From: WELLS Russell (AREVA) [Russell.Wells@areva.com]
Sent: Thursday, March 03, 2011 10:16 AM
To: Tesfaye, Getachew
Cc: BENNETT Kathy (AREVA); DELANO Karen (AREVA); ROMINE Judy (AREVA); WILLIFORD Dennis (AREVA); HALLINGER Pat (EXTERNAL AREVA); HOLM Jerald (EXTERNAL AREVA); BROWNSON Doug (AREVA); RANSOM James (AREVA)
Subject: Revised DRAFT Response to U.S. EPR Design Certification Application RAI No. 432, FSAR Ch. 15, OPEN ITEM
Attachments: RAI 432 Revised Response US EPR DC - DRAFT.pdf

Request for Additional Information No. 432(4958), Revision 1

U.S. EPR Standard Design Certification
AREVA NP Inc.
Docket No. 52-020
SRP Section: 15.00.02 - Review of Transient and Accident Analysis Methods
01/2006
Application Section: 15.0.0.3.1

Question 15.00.02-1:

Sheet 2 of 2

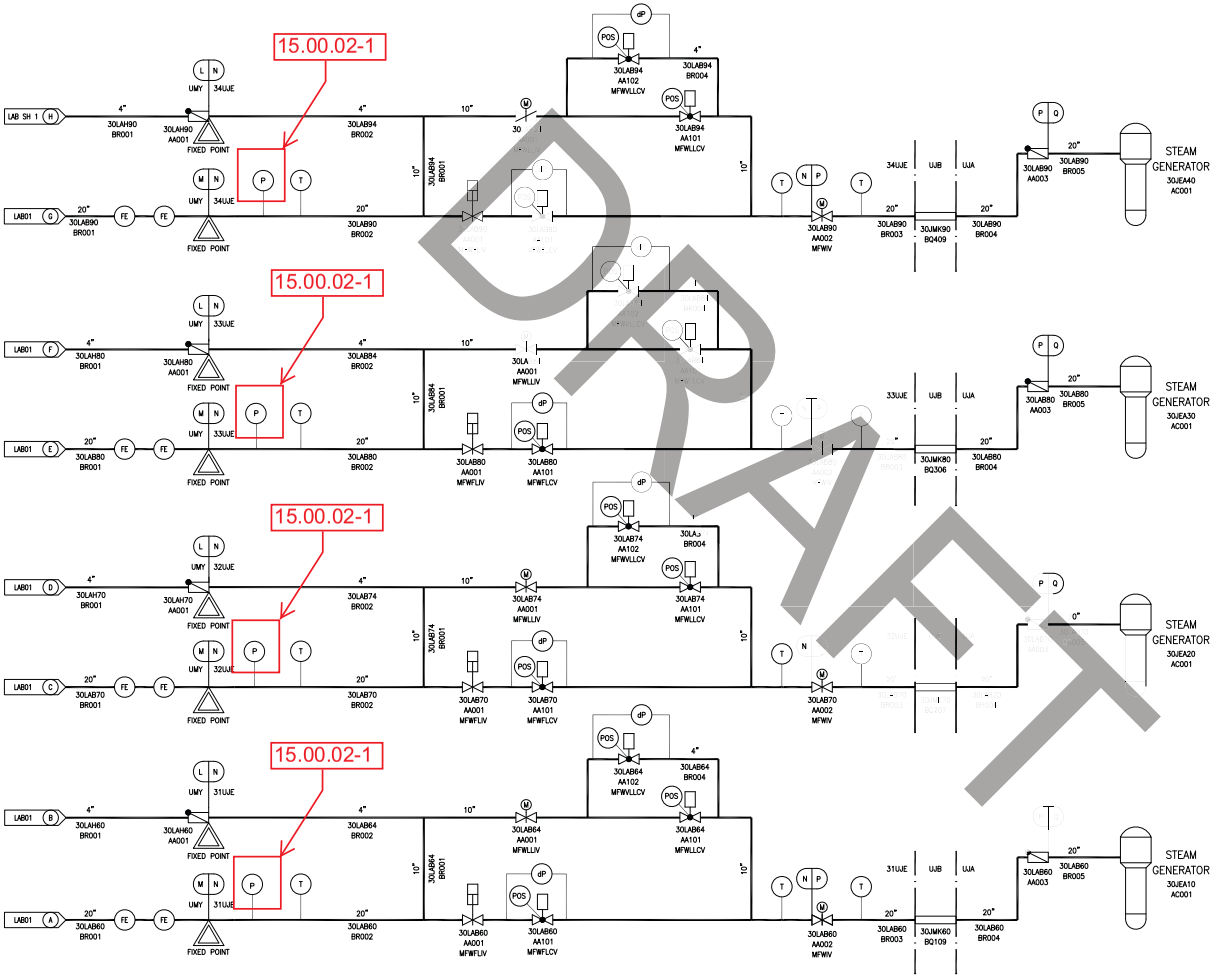
However, EPR FSAR Revision 1 does not provide sufficient information of the instrumentation and/or methodology for the main feedwater flow measurement, nor provide a basis for the statement that the main feedwater flow measurement supports a 0.48% power uncertainty.

- Feedwater flow rate for each train of feedwater (refer to U.S. EPR FSAR Tier 2, Section 10.4.7.5 and Figure 10.4.7-1).
      - Feedwater temperature for each train of feedwater (refer to U.S. EPR FSAR Tier 2, Section 10.4.7.5 and Figure 10.4.7-1).
      - Feedwater pressure for each train of feedwater. U.S. EPR FSAR Tier 2, Figure 10.4.7-1 will be revised to show the pressure sensors.
      - Steam generator (SG) blowdown flow rate for each SG (refer to U.S. EPR FSAR Tier 2, Figure 10.4.8-1).
      - SG blowdown temperature for each SG (refer to U.S. EPR FSAR Tier 2, Figure 10.4.8-1).

U.S. EPR FSAR Tier 2, Table 1.8-2, Section 7.7.2.3.5, and Figure 10.4.7-1 will be revised as described in the response and indicated on the enclosed markup.
